KINGSTON FOSSIL PLANT - ANNUAL ASH POND DIKE STABILITY INSPECTION

ANNUAL ASH POND DIKE
STABILITY INSPECTION
2007

Prepared by: John Albright and Jeff Gray
Date: January 31, 2007

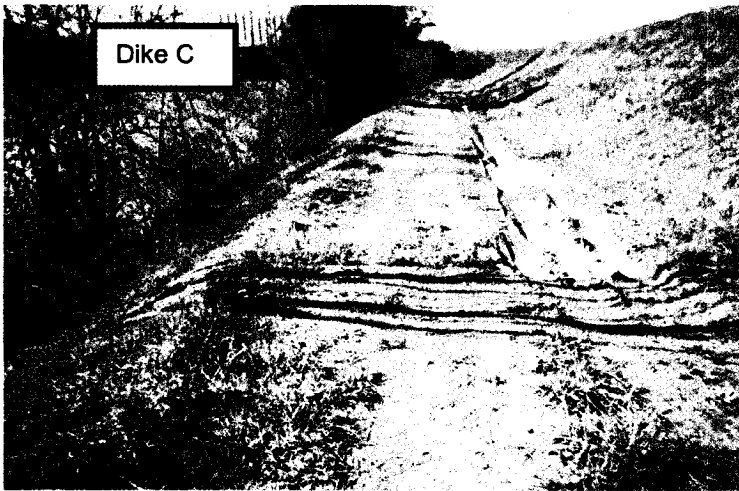
All exterior dike slopes around this area appeared to be in sound condition with excellent vegetative cover. The dikes had been mowed recently and were in very good condition. As shown to the left, some of the benches don't drain well. As much as practical, these ditches should be graded so they will drain, even if slowly. Wheel ruts that hold water should be filled with soil and covered with stone if they are in a road.

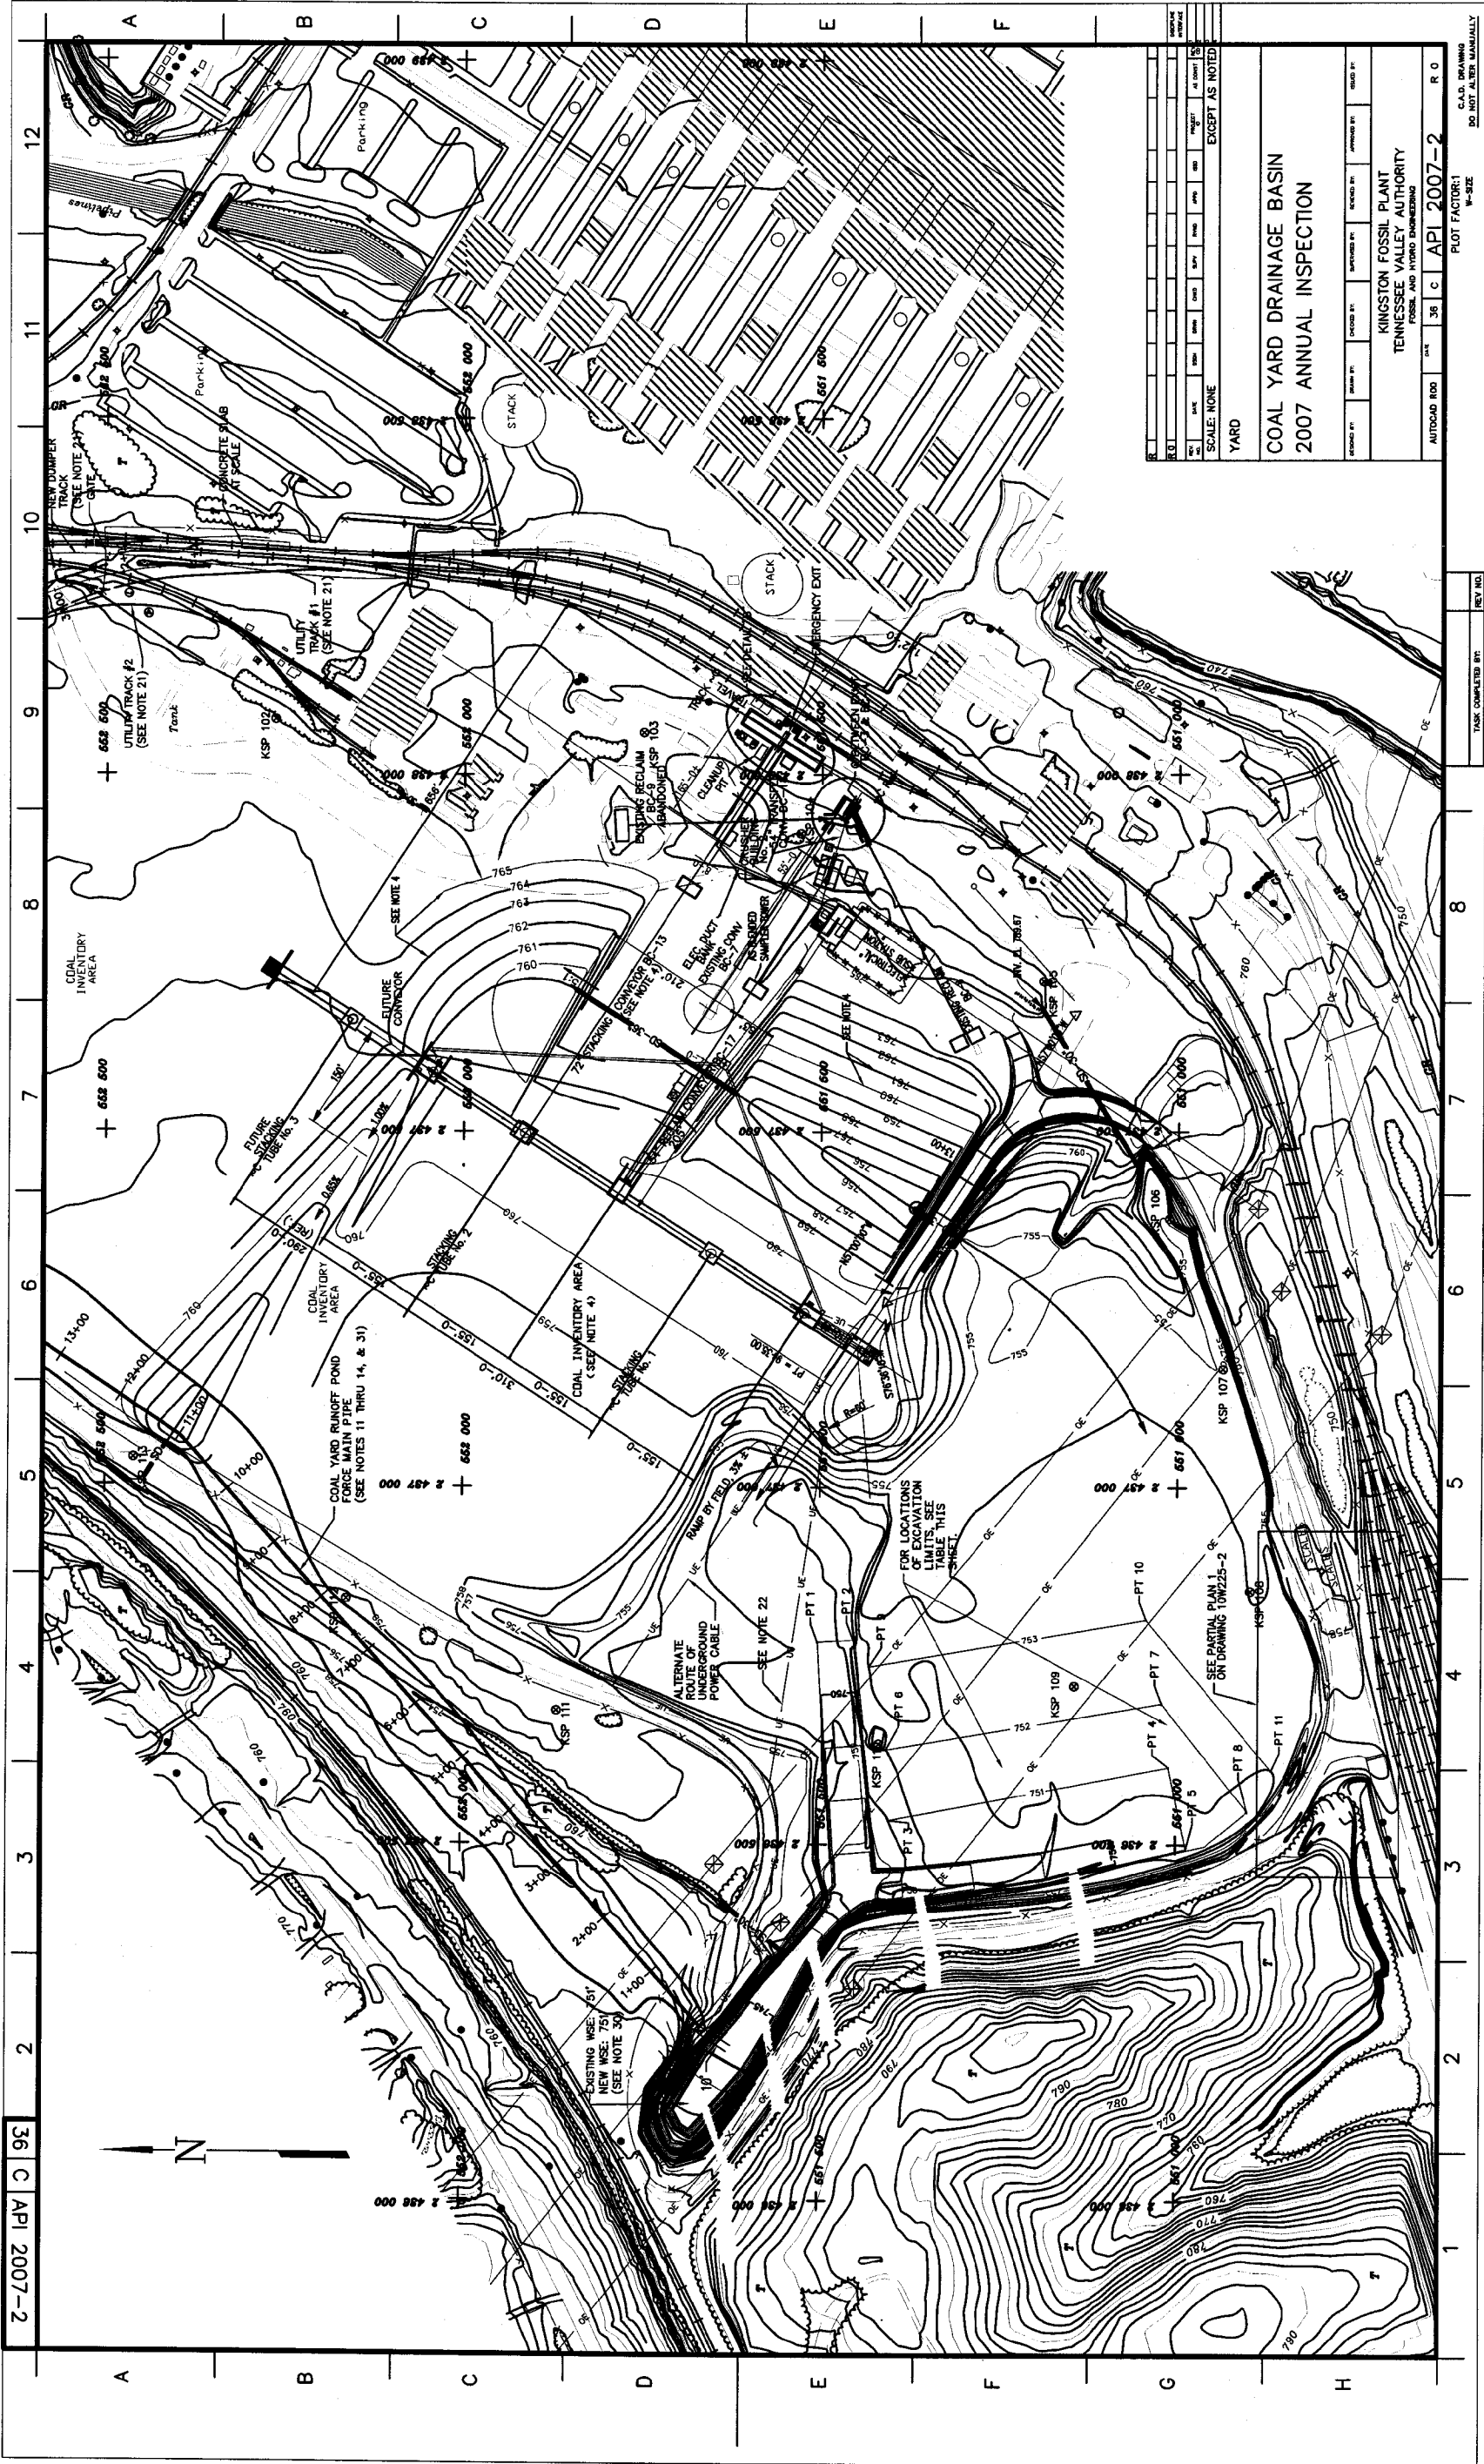
contained coal yard sediment. TVA drawing 10W225-2 (attached as API 2006-2) shows the pond and its intended bottom contours.

- Dredge the Coal Yard Drainage Basin to restore its design contours and protect the pumps from further damage. There is an estimated 2,800+ cubic yards of sediment in the original pond and an extra 3,400+ cubic yards in the "V" section that needs to be removed as soon as reasonable. See the attached copy of 10W225-2. We estimate \$50,000 will be needed, depending on haul distance.

36 C API 2007

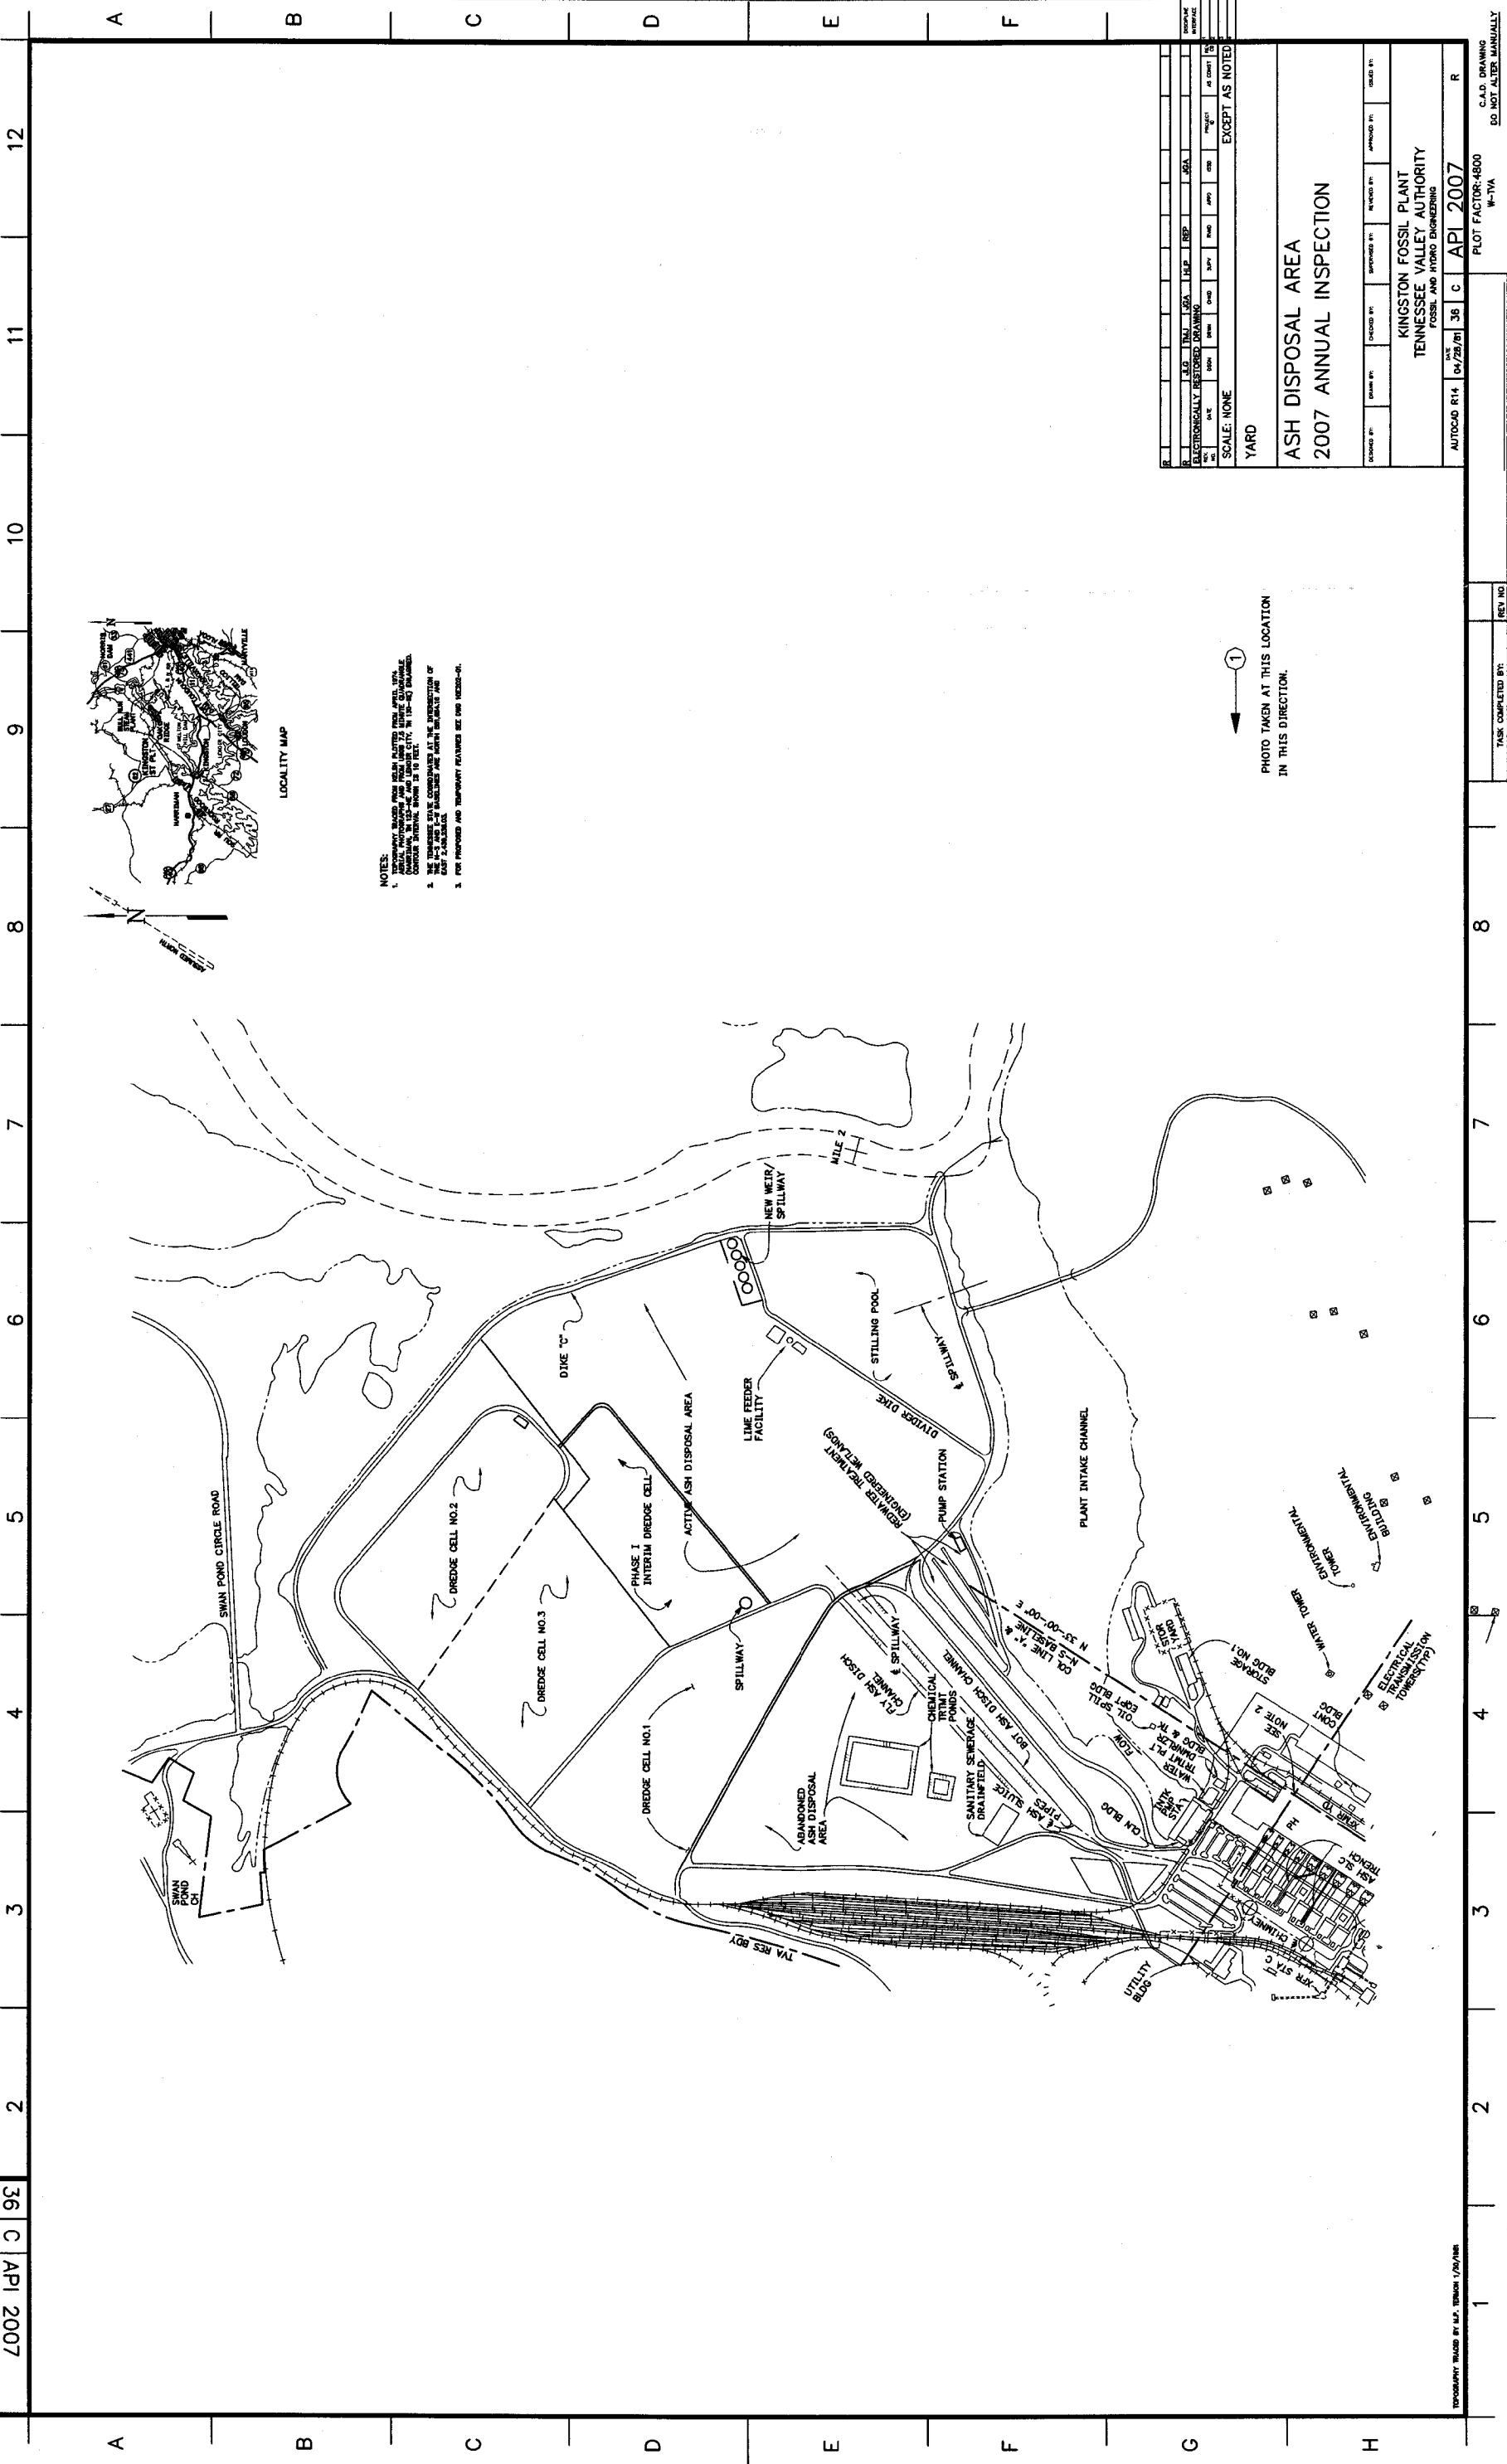
Bottom ash is sluiced into a channel southwest of the disposal area where it settles out and is removed by drag line, approximately once a week, to be used for dike construction. Fly ash is sluiced into a channel northwest of the bottom ash channel. Both channels flow northeast into the active ash pond where the fly ash settles out and accumulates. Please see drawing API 2007.
